SERVICE PROCEDURE

G-05523-R1
February 2006

**SUBJECT: SAFETY RECALL (U.S., EXPORT)
ENGINE GROUND CABLE on certain 7000 and 8000
Series Models built 3/1/2003 thru 7/28/2005 with
Caterpillar® Engines**

G-05523-R2
March 2006

Figure 2 – Properly Clocked Short Engine Ground Cable

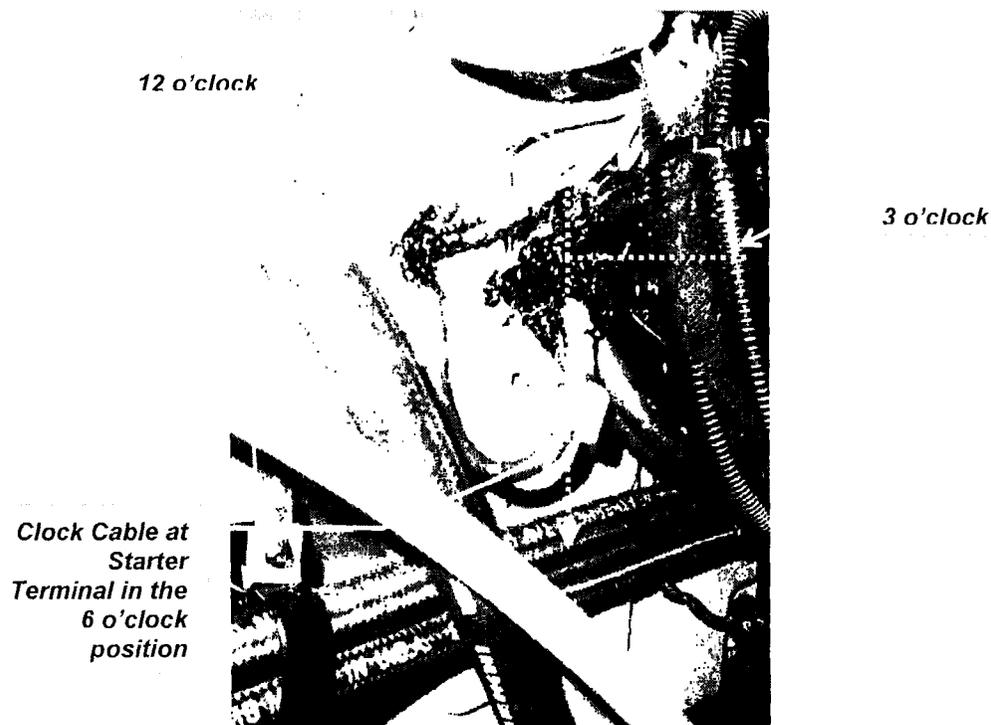
NOTE: Rotate and tighten the new ground cable on the starter terminal so it is straight down (6 o'clock position) and *not* contacting the starter positive cables, see Figure 2.

8. Disconnect negative battery cable from batteries.
9. Remove engine block ground cable.
10. Inspect positive cable for chafing damage. If any chafing of cable is evident, replace damaged positive battery cable and conduit.
11. Replace engine block ground cable with new, shorter cable.

**Figure 3 – Battery Cables to frame rail rub
(Cummins engine shown, however condition may also exist on CAT engines)**

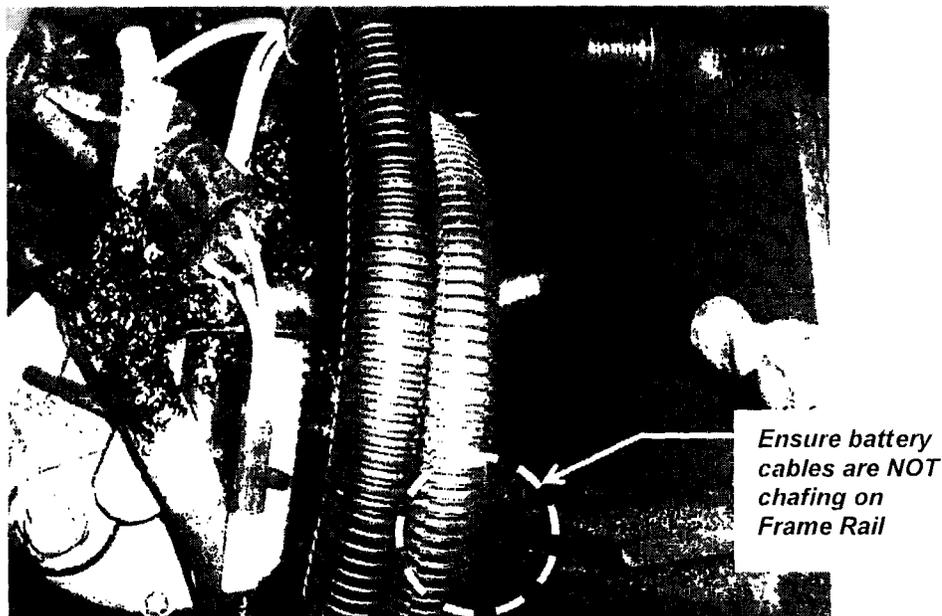
- Regardless of whether or not the saddle clamp was installed, please perform this final inspection on **all** vehicles to ensure the electrical cables are properly routed.
- Please inspect the starter electrical cable routing for rubbing or chafing in the following areas:
 - Battery Cables to frame rail.
 - Battery Cables to FRAME ground cable.
 - Battery Cables to ENGINE BLOCK ground cable .
 - Battery Cables to starter case, starter terminal studs or other starter components and wiring.
 - Battery Positive Cable to BATTERY ground cable.
 - Battery Positive Cable to FUEL FILTER housing.
- It may be necessary to loosen and/or remove a battery cable to re-orient it.
- It may also be necessary to loosen/replace routing/clipping points (p-clamps, extension clips, etc...) to facilitate a no-rub condition.
- See figures below for a representation of rub conditions that require remedied.

Figure 3a – Battery Cables to FRAME GROUND rub

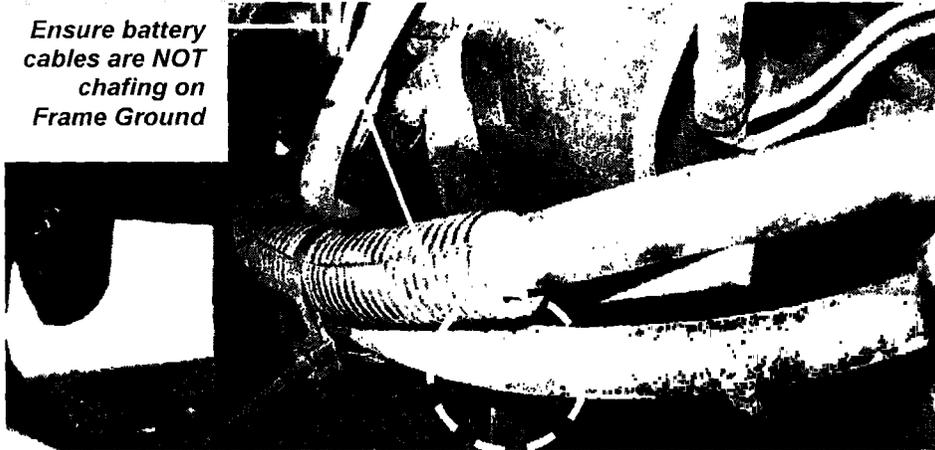
*Ensure battery
cables are NOT
chafing on
Frame Ground*

Figure 3b- Battery Cables to ENGINE BLOCK GROUND rub

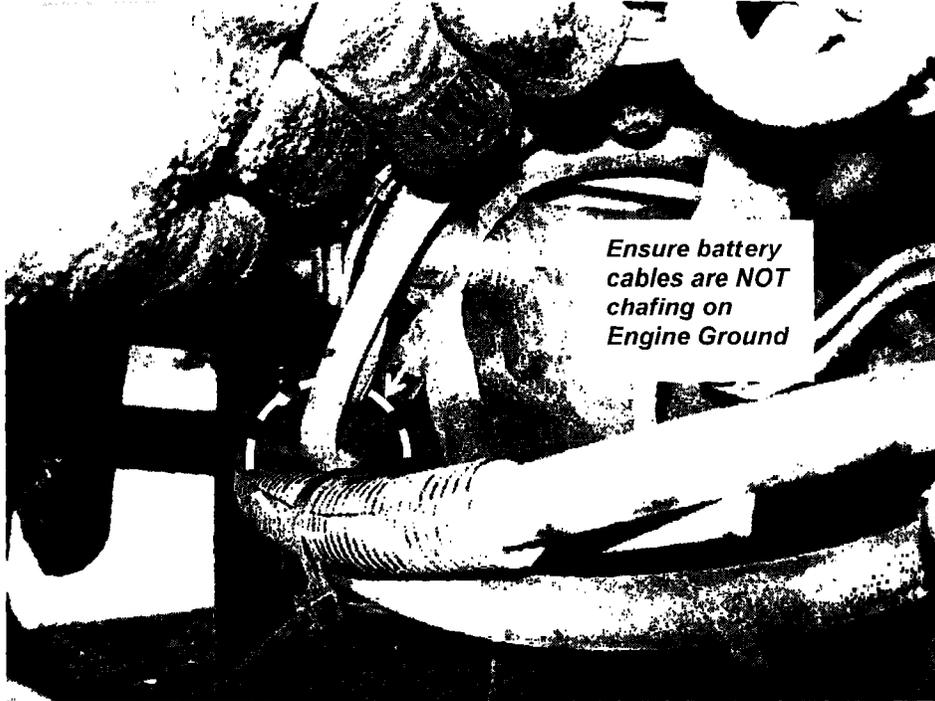
*Ensure battery
cables are NOT
chafing on
Engine Ground*

Figure 2 – Properly Clocked Short Engine Ground Cable

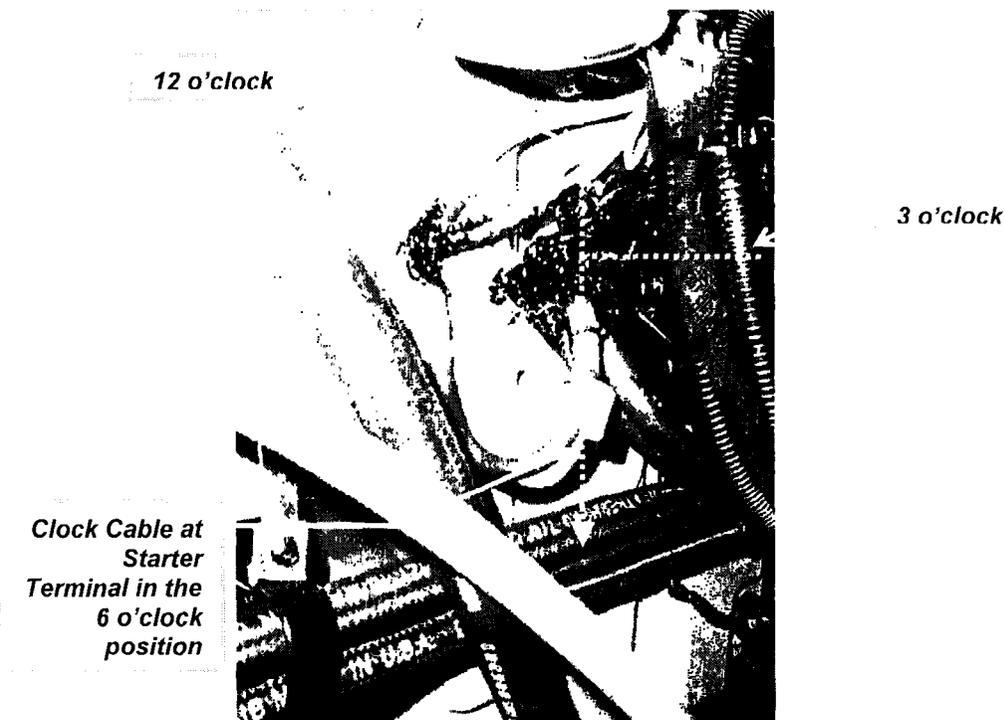
NOTE: Rotate and tighten the new ground cable on the starter terminal so it is straight down (6 o'clock position) and *not* contacting the starter positive cables, see Figure 2.

8. Disconnect negative battery cable from batteries.
9. Remove engine block ground cable.
10. Inspect positive cable for chafing damage. If any chafing of cable is evident, replace damaged positive battery cable and conduit.
11. Replace engine block ground cable with new, shorter cable.

**Figure 3 – Battery Cables to frame rail rub
(Cummins engine shown, however condition may also exist on CAT engines)**

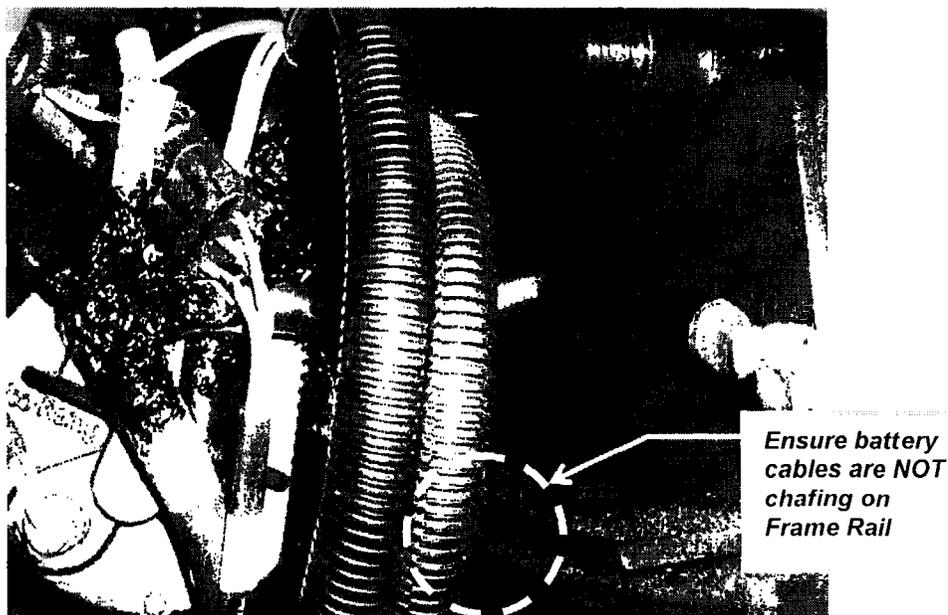
- Regardless of whether or not the saddle clamp was installed, please perform this final inspection on **all** vehicles to ensure the electrical cables are properly routed.
- Please inspect the starter electrical cable routing for rubbing or chafing in the following areas:
 - Battery Cables to frame rail.
 - Battery Cables to FRAME ground cable.
 - Battery Cables to ENGINE BLOCK ground cable .
 - Battery Cables to starter case, starter terminal studs or other starter components and wiring.
 - Battery Positive Cable to BATTERY ground cable.
 - Battery Positive Cable to FUEL FILTER housing.
- It may be necessary to loosen and/or remove a battery cable to re-orient it.
- It may also be necessary to loosen/replace routing/clipping points (p-clamps, extension clips, etc...) to facilitate a no-rub condition.
- See figures below for a representation of rub conditions that require remedied.

Figure 3a – Battery Cables to FRAME GROUND rub

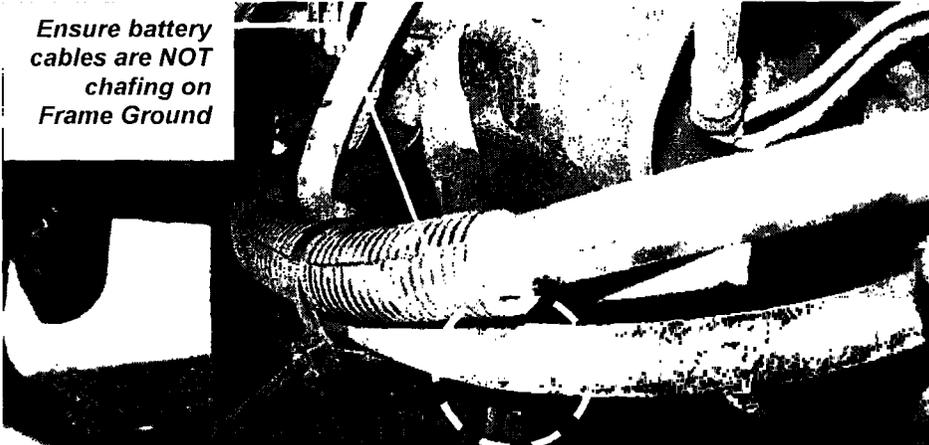
Ensure battery cables are NOT chafing on Frame Ground

Figure 3b- Battery Cables to ENGINE BLOCK GROUND rub

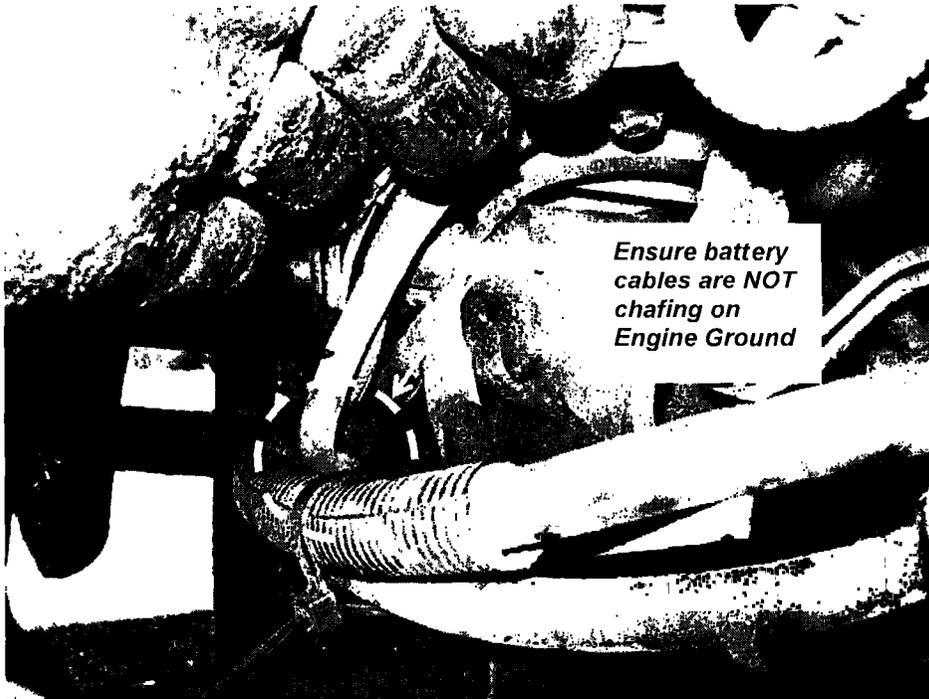
Ensure battery cables are NOT chafing on Engine Ground
